Swanwick Airspace Improvement Programme
Airspace Development 5
Proposed changes to LAC West to improve ATS route connectivity

SAIP AD5
Documentation:
Stage 4 Update and Submit

Step 4A Update Design

Figure 8 N24 eastbound PEMOB NIGIT (proposed route removed) – see para 3.7.2

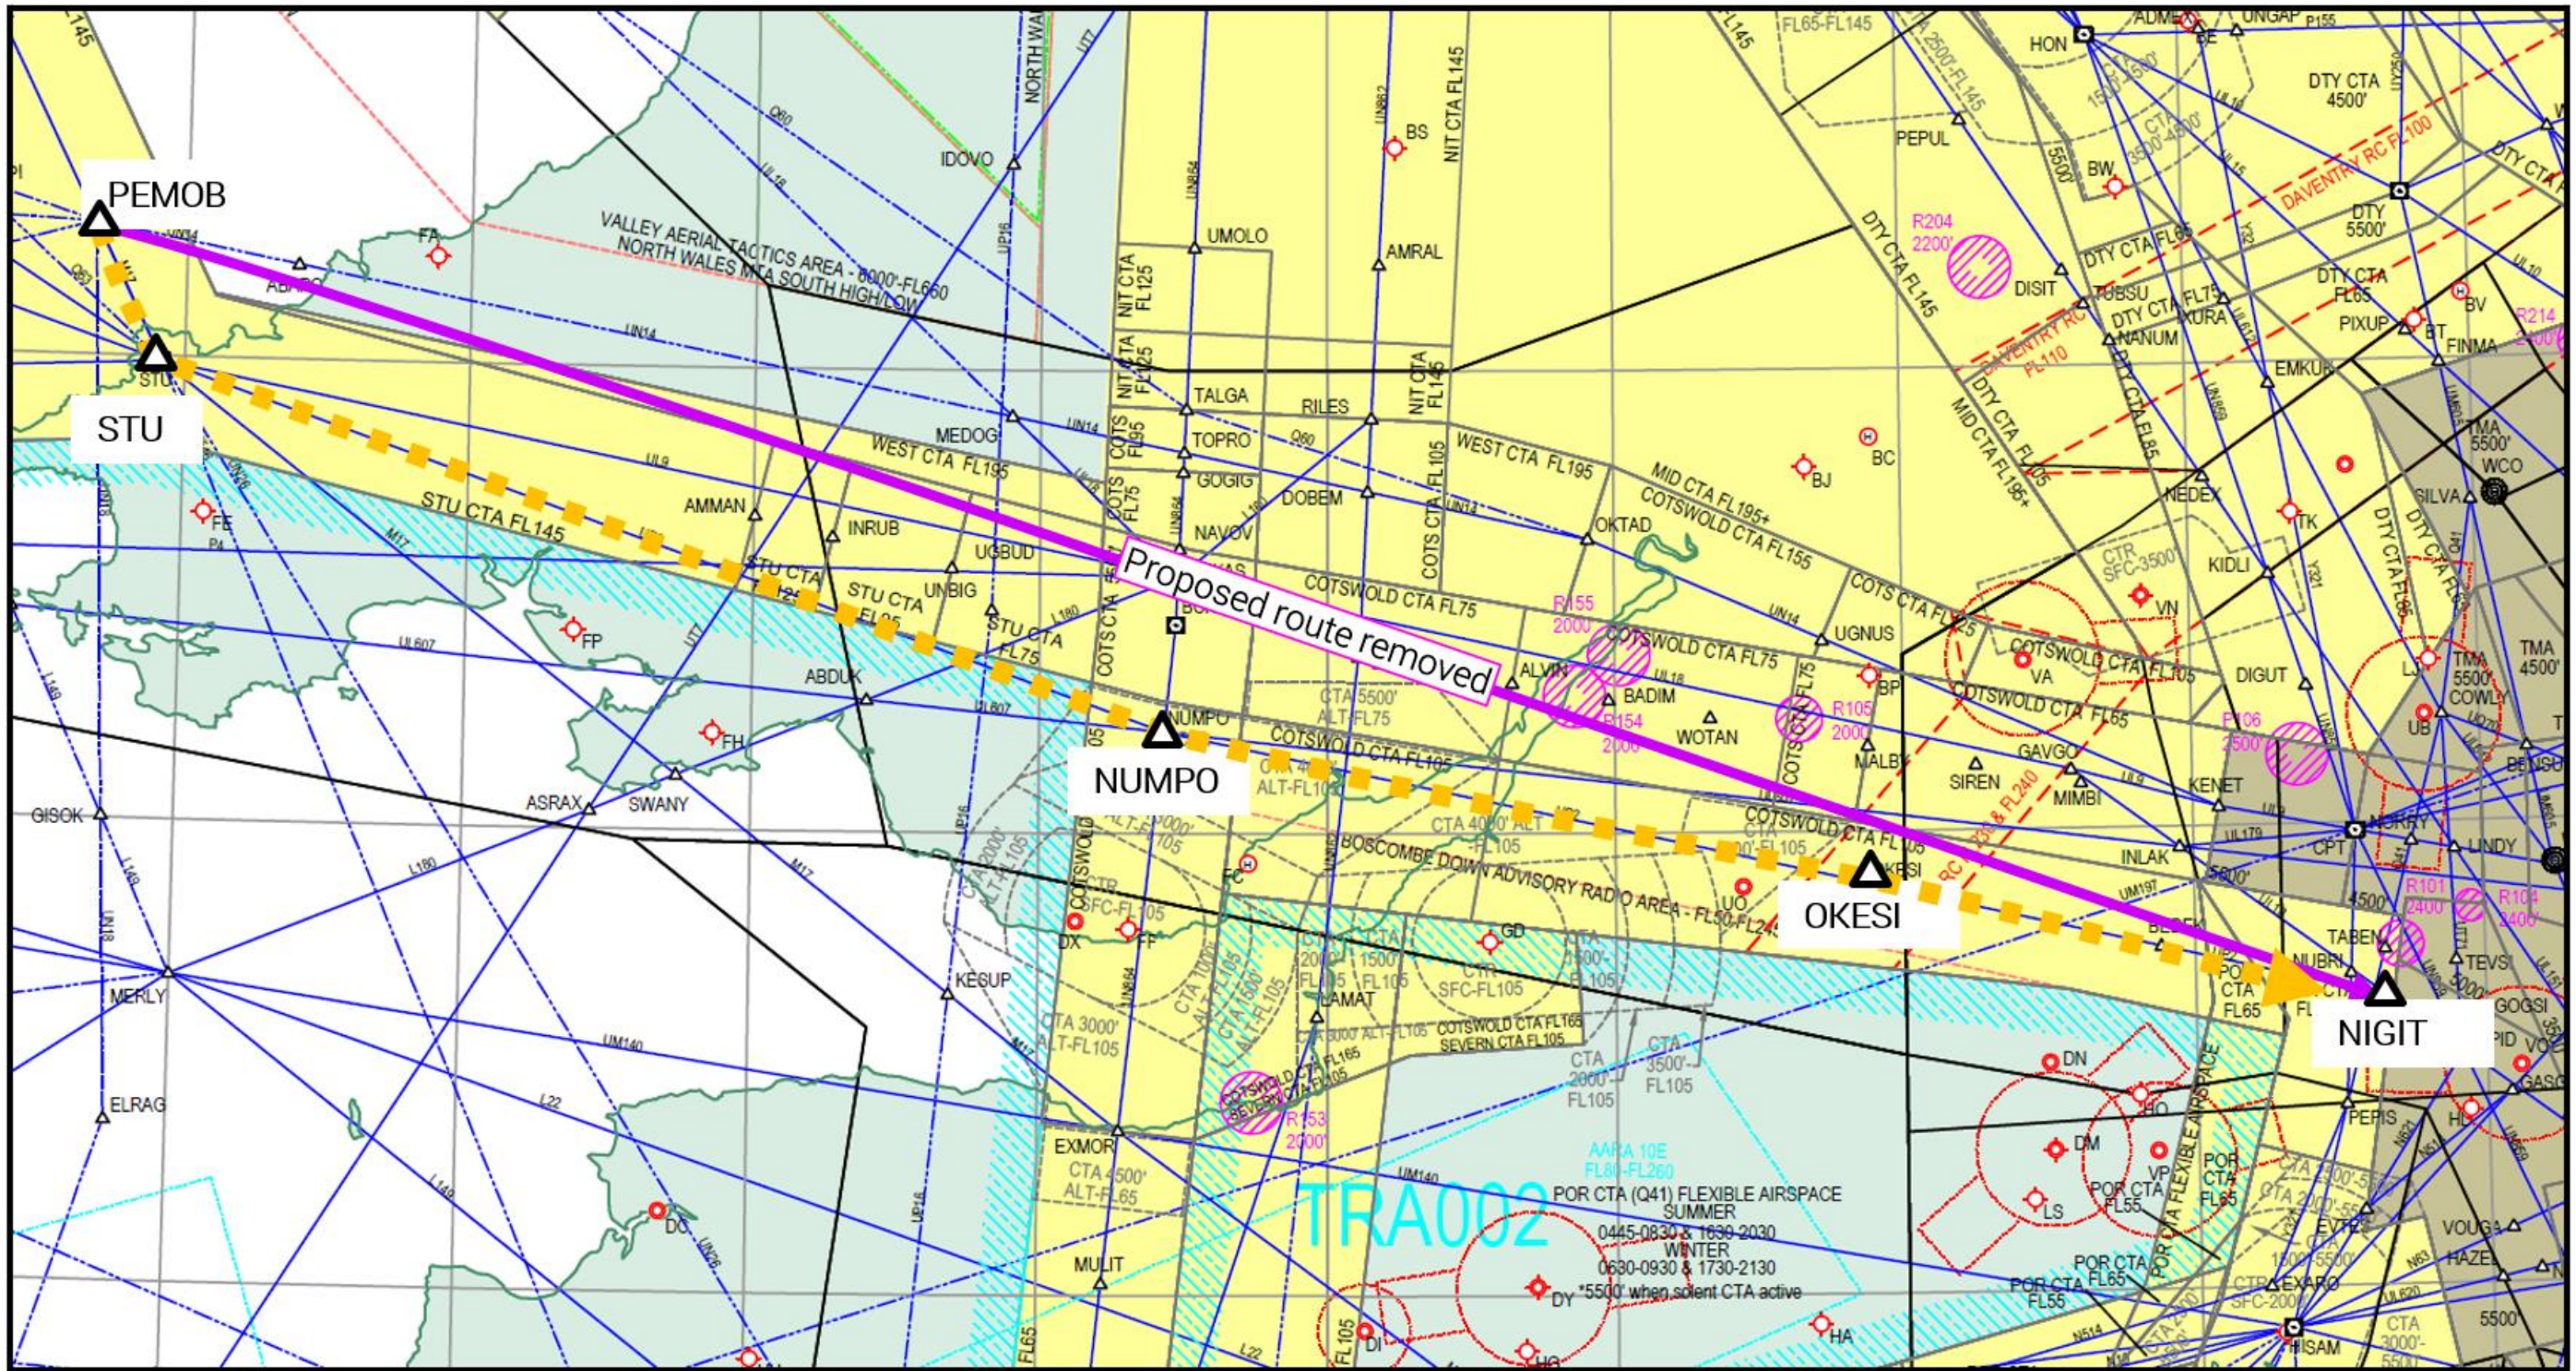
Consultation document Figure 9, this document Figure 8 on page 16.

Due to an error in the fuel benefit calculation for this route, the predicted benefit cannot be accrued. This proposed route (and its erroneous benefit) is removed from the proposal. We apologise for this unfortunate error. As soon as it was discovered, we contacted the key stakeholders, explained the situation, and provided updated fuel benefit figures including those in this section of the document. For details see Step 3D document (Ref 11) para 4.8.

Figure 10 P155 eastbound MORAG HON final proposal – see para 3.7.3

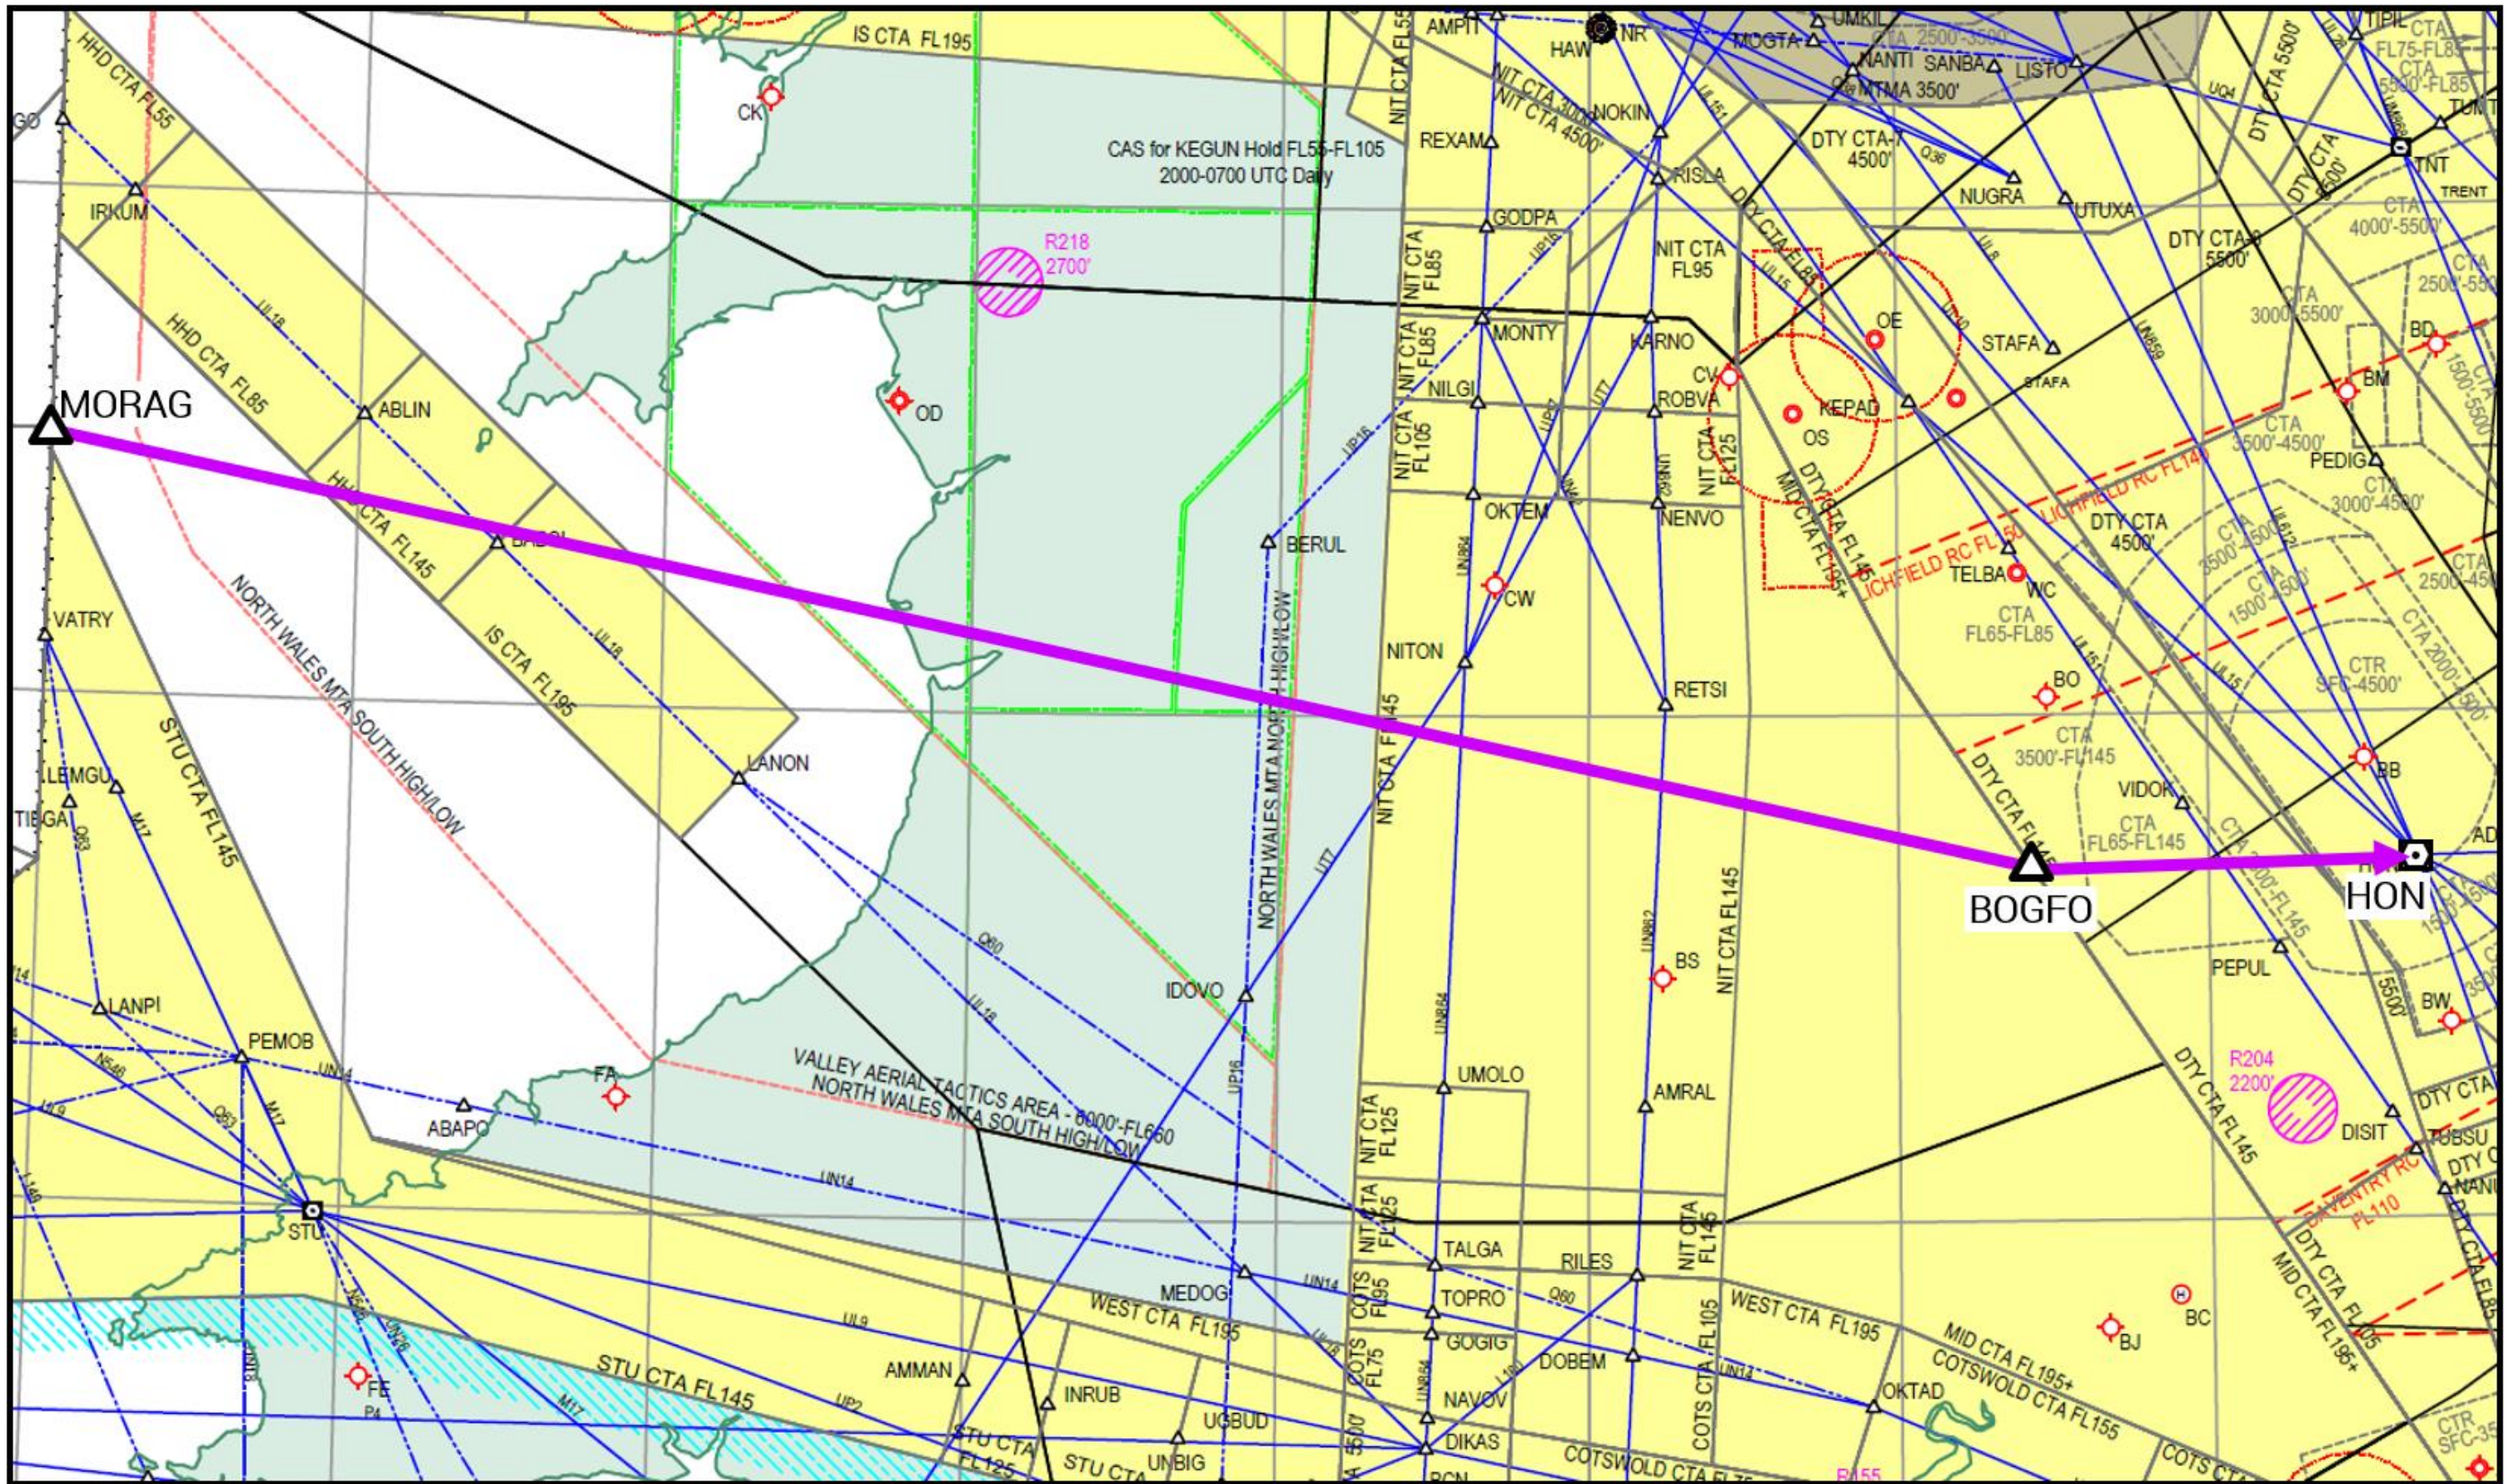
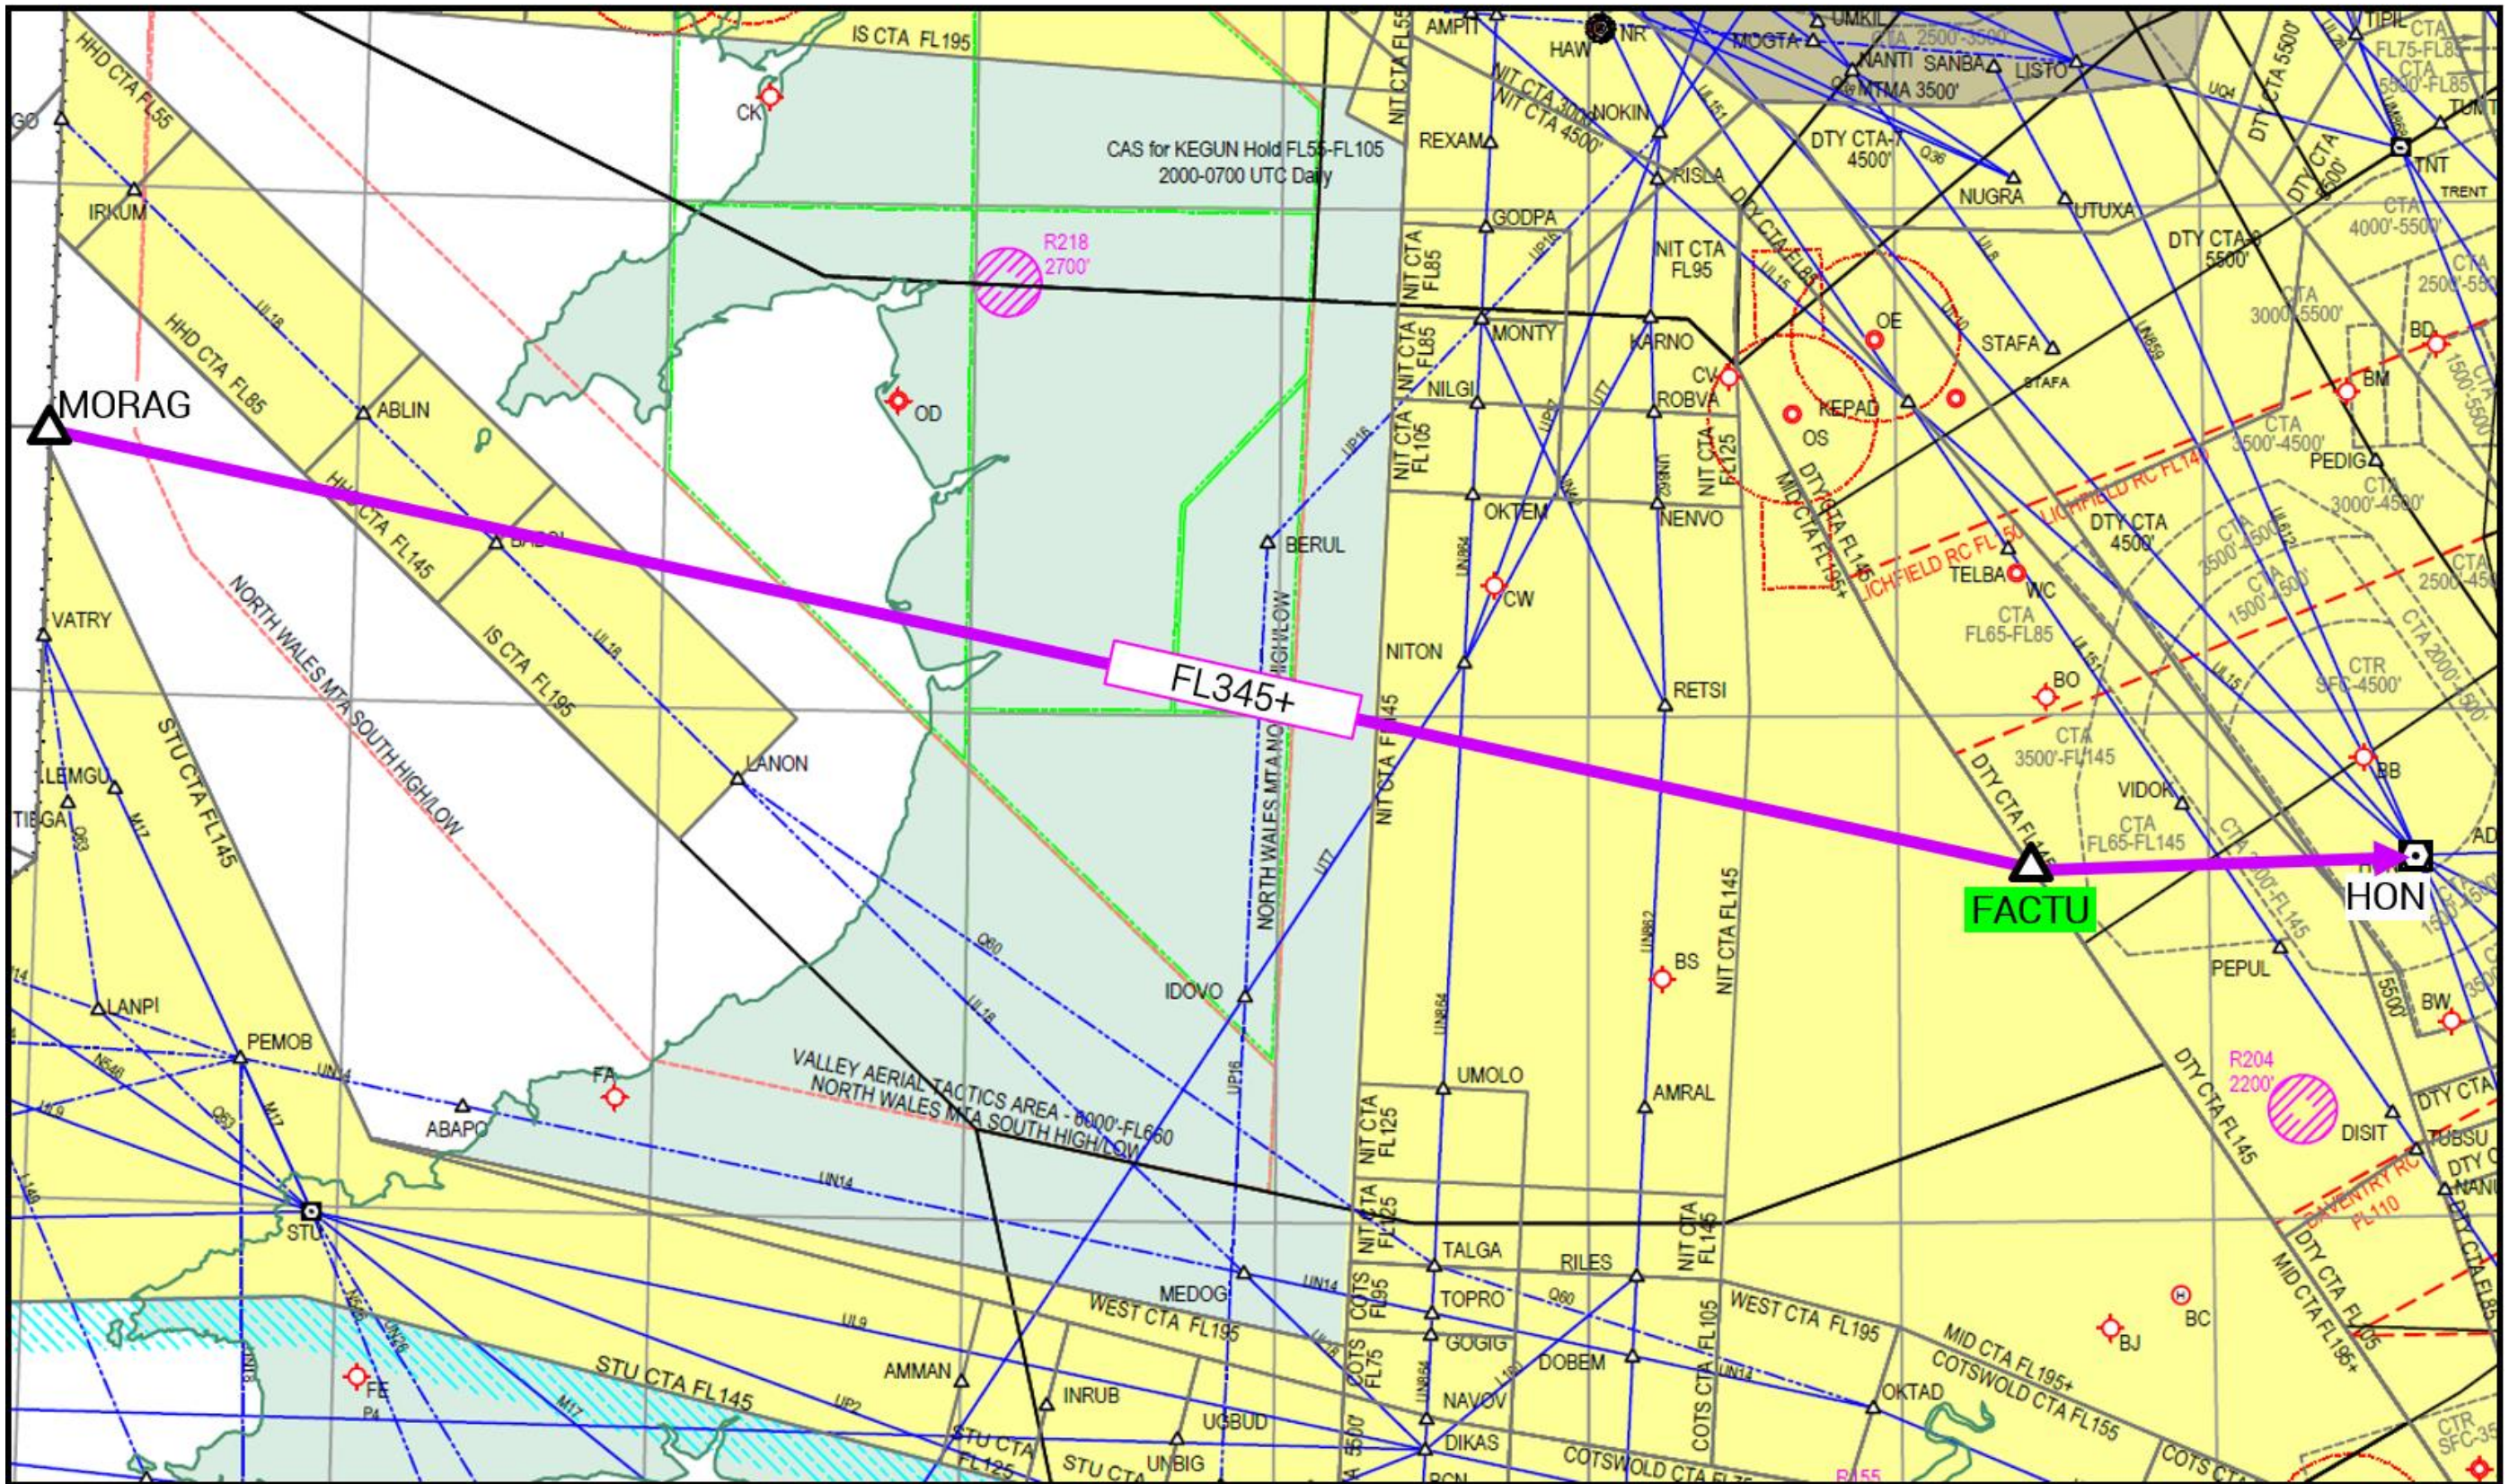
Consultation document Figure 10, this document Figure 9 on page 17 and Figure 10 on page 18.

Waypoint name changed from BOGOF to FACTU. Formal flightplanning restriction FL345+ to minimise potential interactions with S32/S27 LTMA traffic.
